Access Compliance Report

Public Rights-of-Way

(Curb Ramps)

Intersection ID: 43649	Main Street: FERGUSON_FOREST_DR	Cross Street: SWANN_BRANCH_DR	Location: NW
ADA ID: 06C546D4B97F	Ramp Type: Perp	Initial Pass/Fail: Fail	Overall Compliance: No
Severity Score: 13.75			
Codes/Mitigation Info/Possible Solution		Field Measurements/Component Compliance

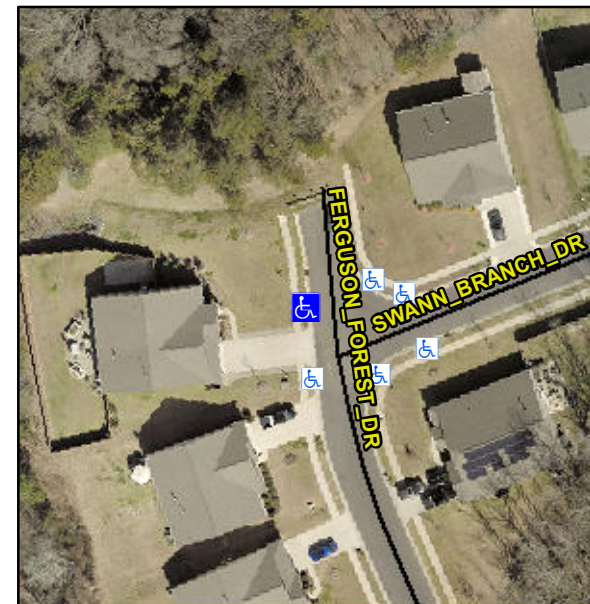
Not Found, R304.2.2, R304.5.3

Compliance	Description	Data	Compliance	Description	Data
N/A	Ramp Length (in)	47.0	No	Ramp Slope (%)	10.6
Yes	Ramp Width (in)	48.0	No	Ramp XSlope (%)	4.3
N/A	Flare Type LT	N/A	N/A	Flare Type RT	N/A
N/A	Flare Slope LT (%)	N/A	N/A	Flare Slope RT (%)	N/A
N/A	Flare Traversable LT?	N/A	N/A	Flare Traversable RT?	N/A
N/A	Landing Length (in)	N/A	N/A	DWS Provided?	N/A
N/A	Landing Width (in)	N/A	N/A	DWS Contrast?	N/A
N/A	Landing Slope (%)	N/A	N/A	DWS Length (in)	N/A
N/A	Landing X Slope (%)	N/A	N/A	DWS Full Width?	N/A
N/A	Landing Curb? (Y/N)	N/A	N/A	DWS Offset (in)	N/A
N/A	Shared Landing?	N/A			
N/A	Gutter Ponding?	N/A	N/A	Gutter Slope (%)	N/A
N/A	Gutter Lip Ht (in)	N/A	N/A	Gutter X Slope (%)	N/A
N/A	Painted X Walk1?	No	N/A	Painted X Walk2?	N/A
	X Walk 1 Direction	To E		X Walk 2 Direction	N/A
N/A	X Walk 1 Width (in)	N/A	N/A	X Walk 2 Width (in)	N/A
	X Walk 1 Slope (%)	0.1		X Walk 2 Slope (%)	N/A
	X Walk 1 X Slope (%)	1.7		X Walk 2 X Slope (%)	N/A

Remove & Replace Entire Ramp.
